PLANNING PROPOSAL PP0002/15

To facilitate a number of amendments (primarily minor policy and 'house-keeping' matters) to the Pittwater Local Environmental Plan 2014

February 2016

Attachment 4.21

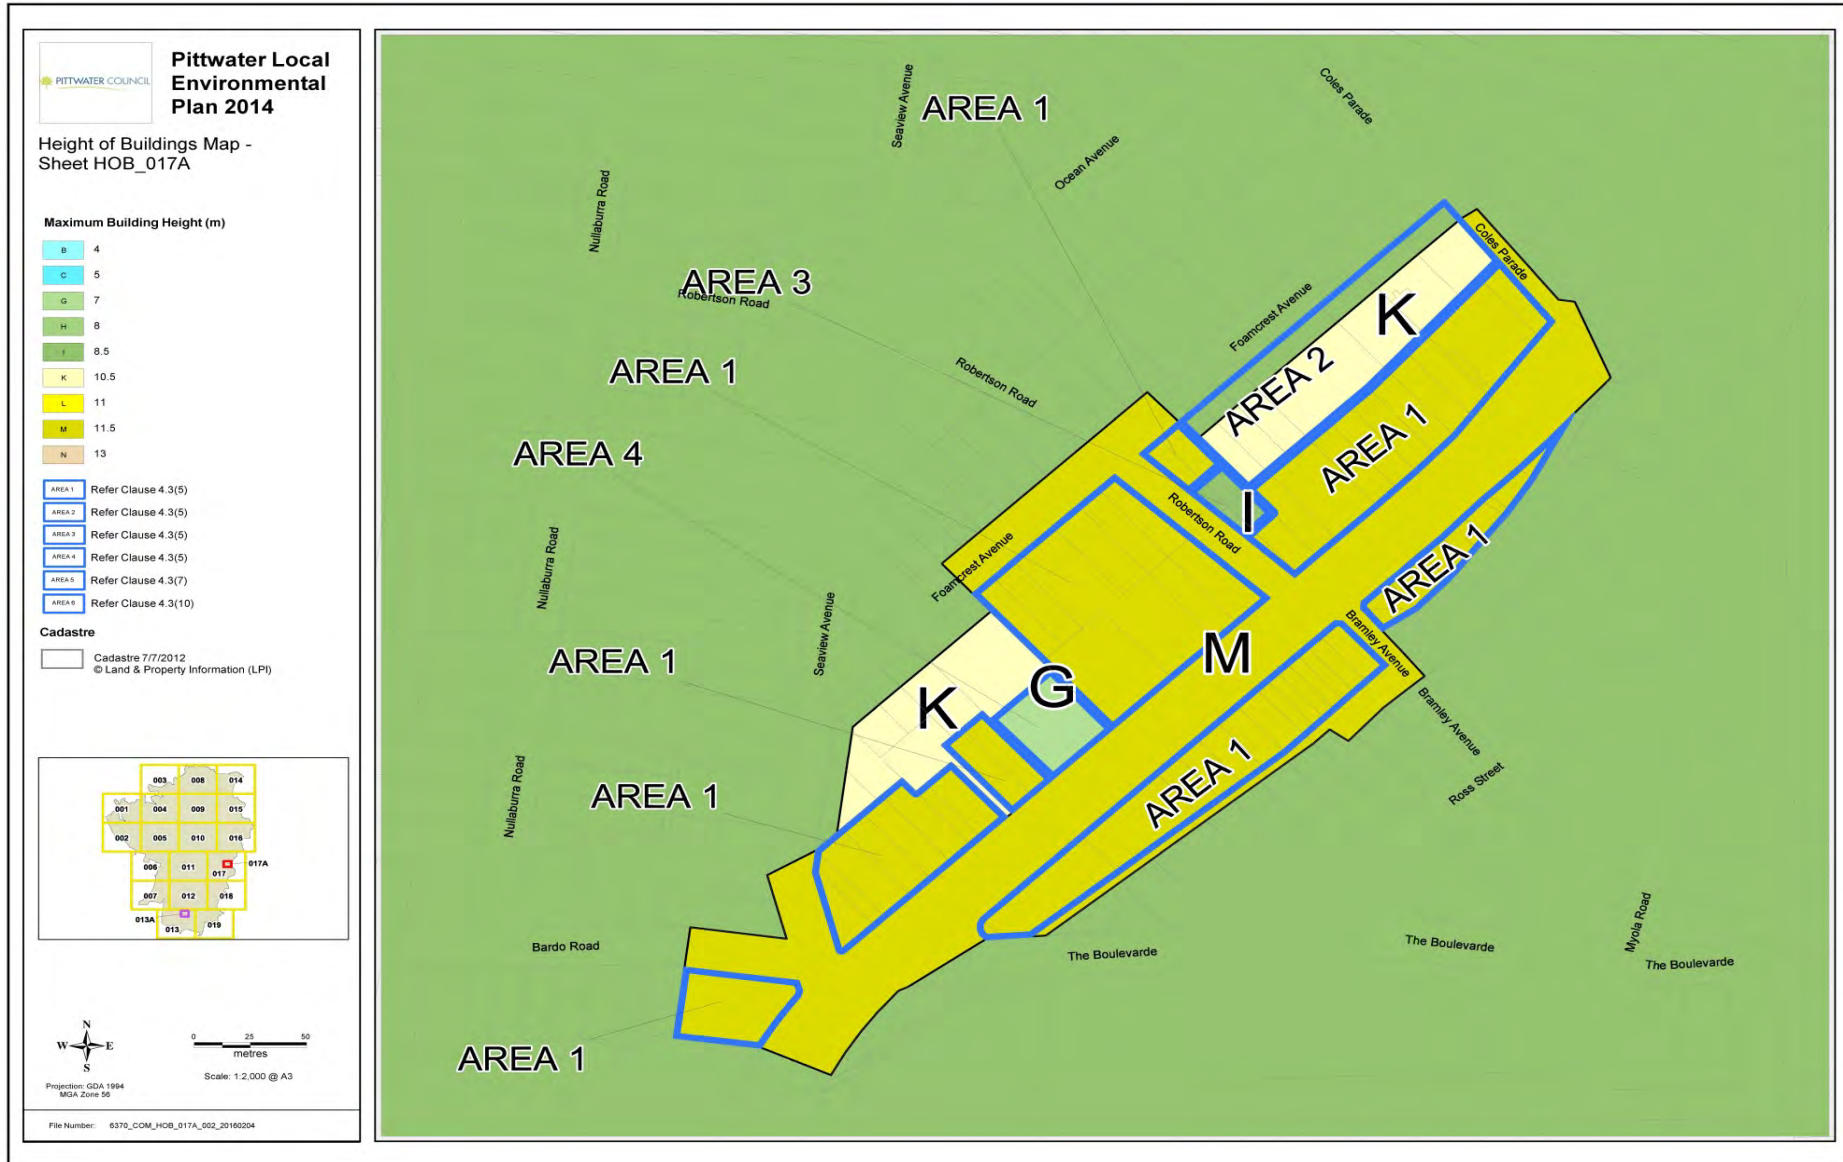
3	<p>Amend the Height of Buildings Map Grid Map 012 in relation to 14 Orchard Street, Warriewood (Sector 901F), as per Attachment 4.21.</p>	<p>The proposed amendment is intended to rectify an error on the Height of Buildings Map in relation to Sector 901F of the Warriewood Valley Urban Release Area.</p> <p>The amendment will ensure that the height conveyed on the Height of Buildings Map is consistent with the boundary of the Warriewood Valley Urban Release Area and the Land Zoning Map. It will ensure that on 14 Orchard Street, Warriewood (Sector 901F) a 10.5 metre height limit only applies to the area within the Warriewood Valley Urban Release Area and that an 8.5 metre height limit applies to the area outside the Warriewood Valley Urban Release Area.</p> <p>14 Orchard Street Warriewood Valley was considered under the Warriewood Valley Strategic Review Report 2012 (2012 Strategic Review) which was prepared by Pittwater Council in collaboration with the Department of Planning and Infrastructure.</p> <p>The 2012 Strategic Review recommended a density of 10 dwellings per developable hectare for 14 Orchard Street, which equates to a maximum dwelling yield of 14 dwellings which is reflected in clause 6.1(3) of Pittwater Local Environmental Plan 2014.</p> <p>Adjoining Sectors 901D and 901E (also known as 1 Fern Creek Road and part 12 Orchard Street) have the same density of 10 dwellings per developable hectare and have an 8.5 metre maximum building height as reflected on the Height of Buildings Map Sheet HOB_012.</p> <p>At the density of 10 dwellings per developable hectare, it is anticipated that the residential form would be of a lower scale and not requiring a building height above 8.5 metres which is the standard generally applied to the broader Pittwater LGA.</p> <p>The maximum 10.5 metre building height requirement was to apply to those sectors along Macpherson Street, Garden Street and Orchard Street that have been allocated a density of 32 dwellings per developable hectare subject to the building height along the immediate street frontages being limited to 8.5 metres.</p> <p>This was the intent of the recommendations of the 2012 Strategic Review as agreed to by then Director-General of Planning and adopted by Pittwater Council.</p>

Attachment 4.22

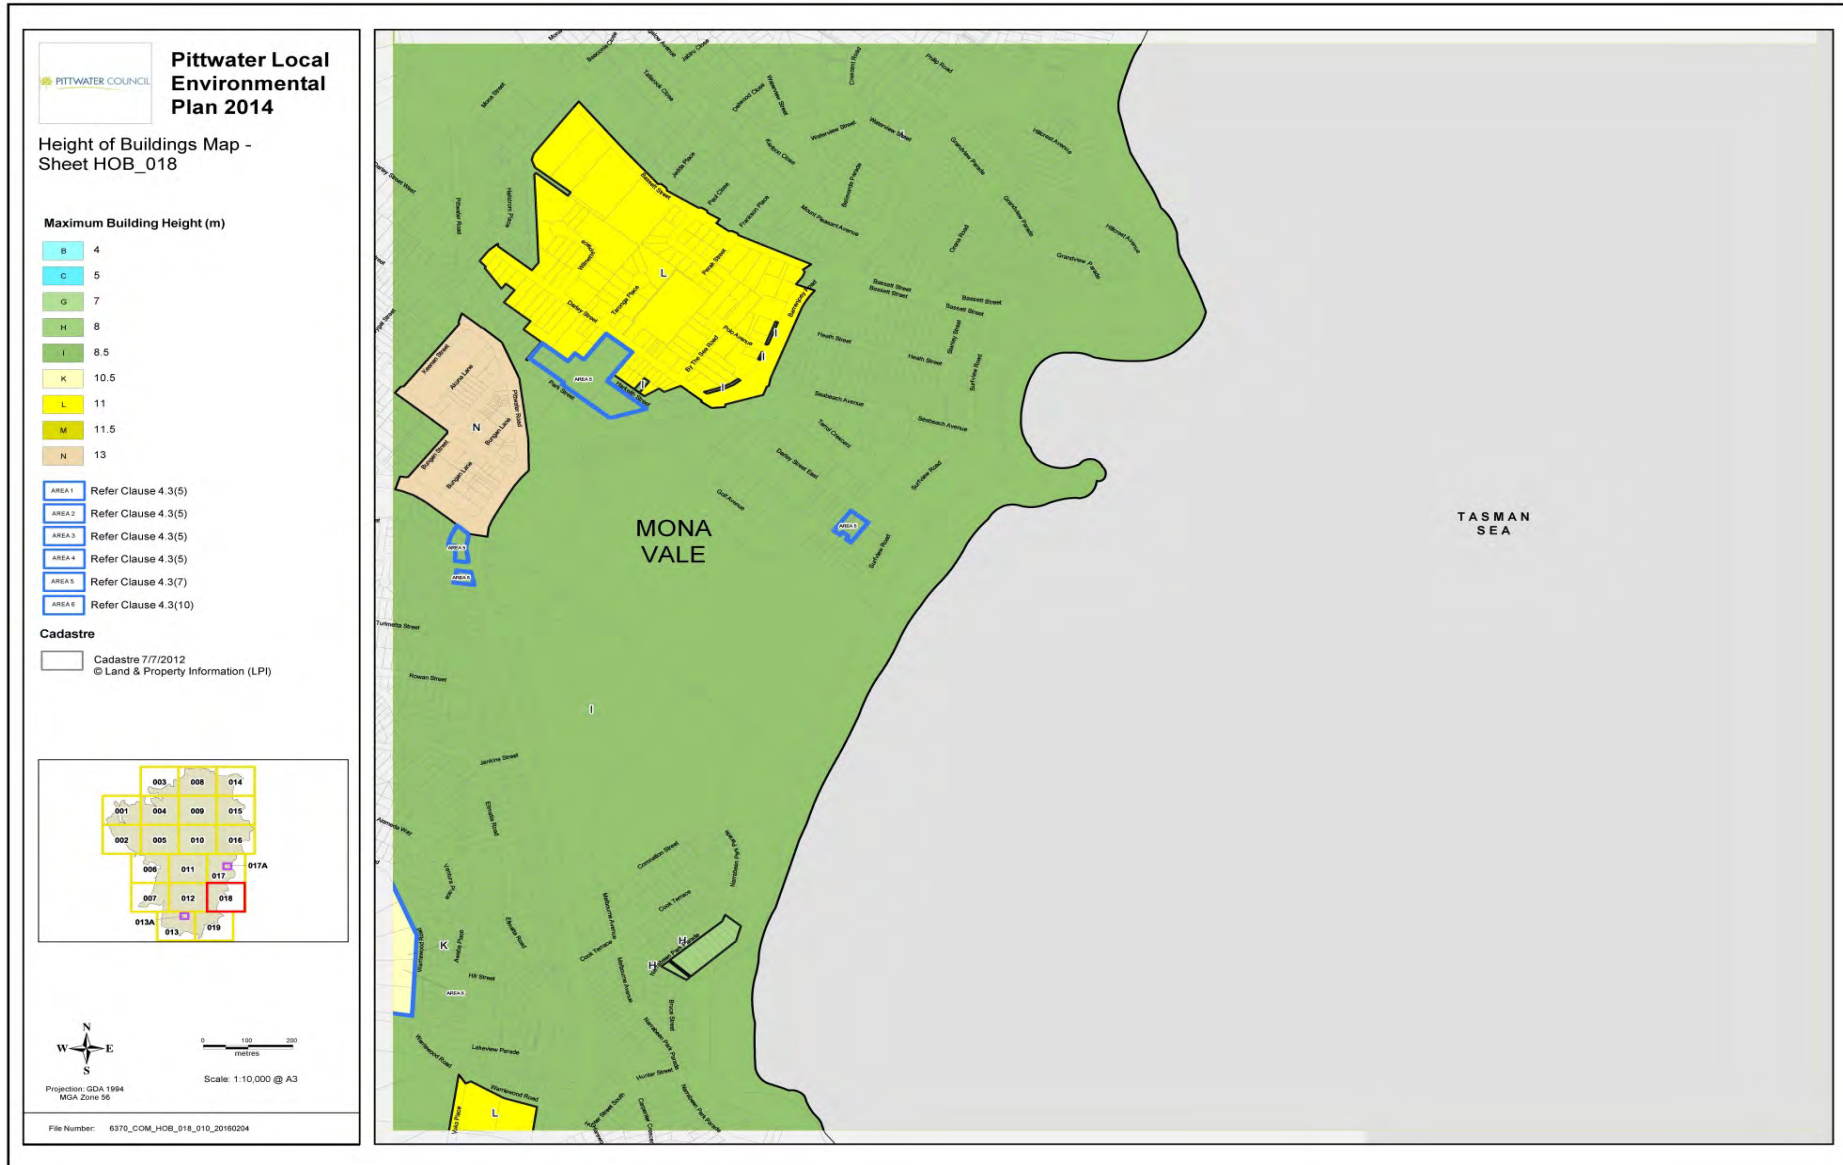
7	<p>Amend the Height of Buildings Map Grid Maps 013 and 017 as per Attachments 4.22 and 4.27.</p>	<p>The proposed amendment is intended to provide improved readability of the Height of Buildings Map and consistency with approved masterplans in relation to the Elanora and Newport commercial centres.</p>

<p>Since the Pittwater LEP 2014 was made, issues have arisen with determining the height standard on the Height of Buildings Map in certain centres. To improve the readability, it is proposed to include inset maps at a larger scale for the Elanora and Newport commercial centres. This amendment also ensures that the inset maps are as accurate as possible in locating the boundary between different height controls, consistent with the approved masterplans.</p>
--	--	---
